DESIGN FAULT 2

Construction of the non-return flap valves

Fig 3. If we then dismantle this flap valve assembly:

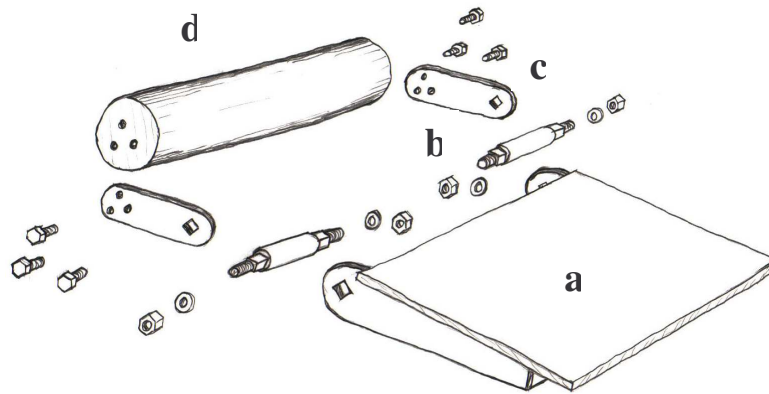
Each of the holes in the above sketch (including those for the spindle square drive) would have been dimensioned to provide tolerances and clearances to their mating parts. The role of these clearances is to enable the flaps to be assembled and the spindles to be aligned within their Oilite bearings.

Comment: If the flaps are loosely assembled (i.e. the nuts and bolts are not tightened), it is apparent that the flap assemblies are **not inherently rigid** and that a certain amount of flexibility or twisting is possible until the clearances and tolerances in the boltholes are taken up.

Minor slippage at one of the assembly's connections (say between parts **b** and **c** in the sketch on the previous page) would result in twisting or distortion of the flap assembly and subsequent misalignment of the steel spindles within their bearings.

Fig. 4 section through chute

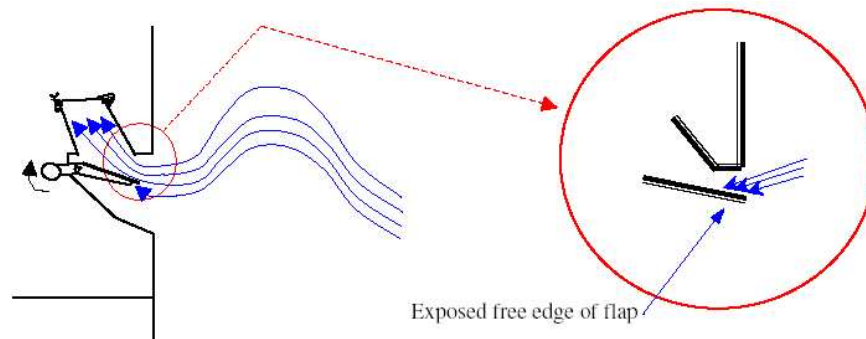
However, if, for any reason, the flaps were not fully closed, the force of the sea could act on the exposed edge of the flap and push it open.

Additionally, in heavy weather, wave loading on the flap valve plate could cause the flap plate to rotate and slam against the chute plating.

It has been calculated that the dynamic loads arising from relatively modest waves (say 5m) acting in this way on the flap plate, would be sufficient to cause slippage at one of the flap's bolted (friction) connections.

Fig 5. Flap assembly with alternative welded connection

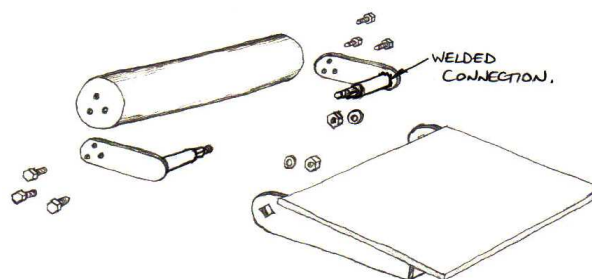
This design fault would have not been present if, instead of a nut and square drive connection, the spindles and the counterbalance arms (parts **b** and **c**) had been joined together by means of welding:

Dismantling, repairs and maintenance would still have been possible with such an arrangement.
